Responses to Environmental Requests for Additional Information
No. 5026, 5033, & 5035
Bell Bend Nuclear Power Plant

RAI No. 5026 EIS USACE-15

RAI No. 5033 EIS 9.3-38

RAI No. 5035 EIS 9.3-25

Example for
Bridge Measuring

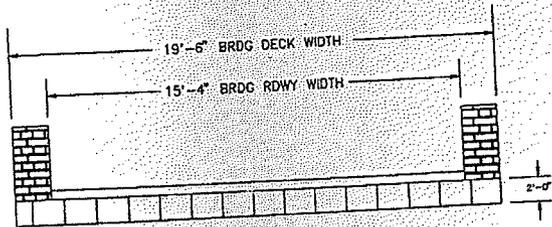
15. Stone Arch Bridge/North Market Street Bridge, Salem Township, Luzerne County: Please supply the correct length measurement of this bridge (see attached guidance for measuring bridges). The submission states that there are only 3 intact stone arch bridges in the county. Our on-line Geographical Information Submission shows that there are over 50 stone arch bridges. Please evaluate this bridge in the context of the bridge survey.
16. Wapwallopen Historic District (potential), Conyngham Township, Luzerne County: Please contact our agency to schedule a site visit to verify the presence and boundaries of a historic district.
